SERVICE BULLETIN

3 Drum Winch Freewheel on Deadman

Doc. No.: 601007-01   **Date: 03/12/2019**

Applicable Vehicles:	10456-10609, 10667, 10696, 10712, 10715, 10723, 10796, 10826, 10836, 10897, 10915, 10969, 10975, 11007, 11008, 11019. 11131, 11178, 11187
Issue Date:	05 December 2019
Overview:	This procedure outlines the actions required to correctly include the deadman foot switch into the circuit controlling the freewheel function.

Figure 2: Example electrical board layout underneath Operator's Console panel

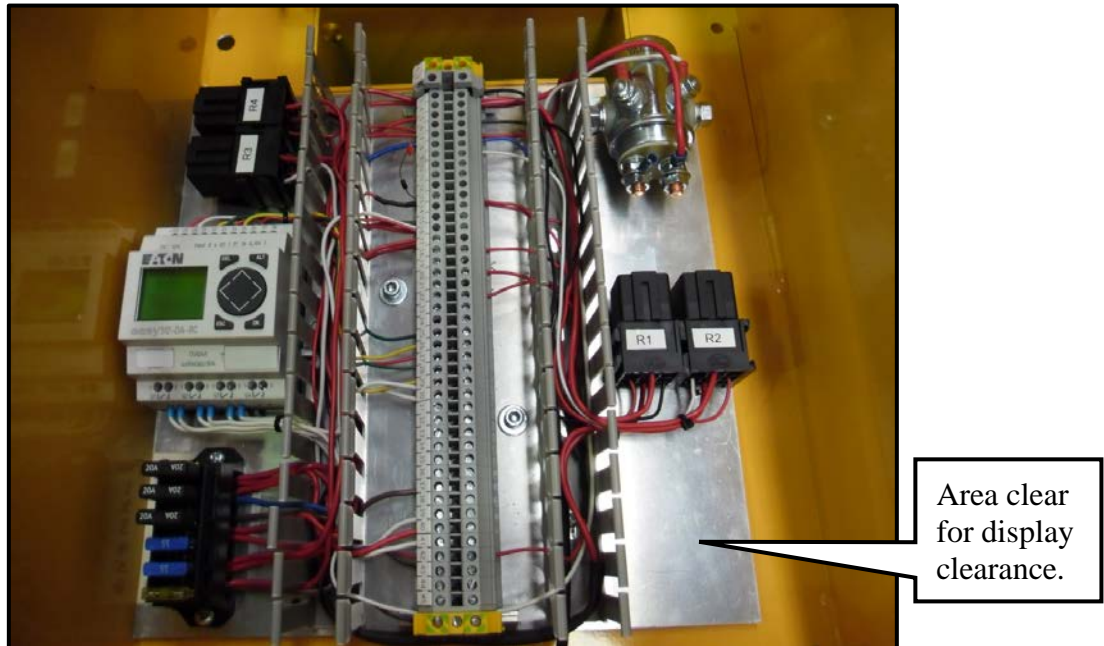
a. Fit relay & relay holder where space is available. The left or right side walls are likely the easiest access. Note that the bottom right corner is to remain clear as the panel mount displays have a long depth.

Figure 6: Original circuit with Freewheel Isolation Relay for SN10796-11187

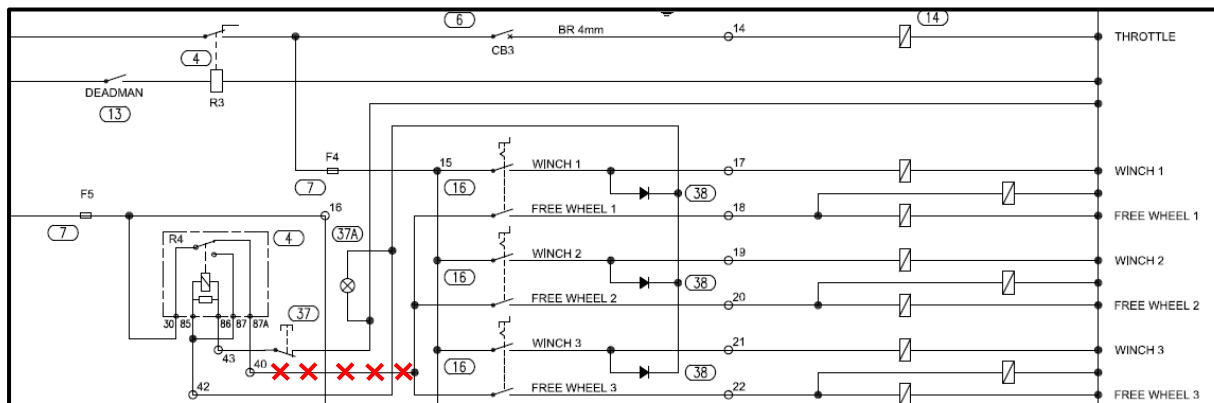
1. Begin with the winch switched off and battery isolated.
2. Remove the Operator's Console panel to access the terminal strip – refer Figure 2.
3. Disconnect the Freewheel Switch wire/s connected to strip Terminal 40 - refer to Figure 6.

4. Ensure that the remaining wire on strip Terminal 40 is still connected to relay R4 terminal 87A.
5. Fit and install relay (R5) then wire as per the following (refer Figure 7):

b. Add wire from strip Terminal 40 to relay R5 terminal 30 (shown with green line highlight).
    c. Add the disconnected Freewheel Switch wire/s onto relay R5 terminal 87 (shown with blue line highlight)

d. Add wire from strip Terminal 15 to relay R5 terminal 85 (shown with red line highlight)
    e. Connect Relay R5 terminal 86 to ground (shown with orange line highlight)

6. Re-fit the console panel and test. Freewheel will now only be possible while the deadman foot switch is pressed.
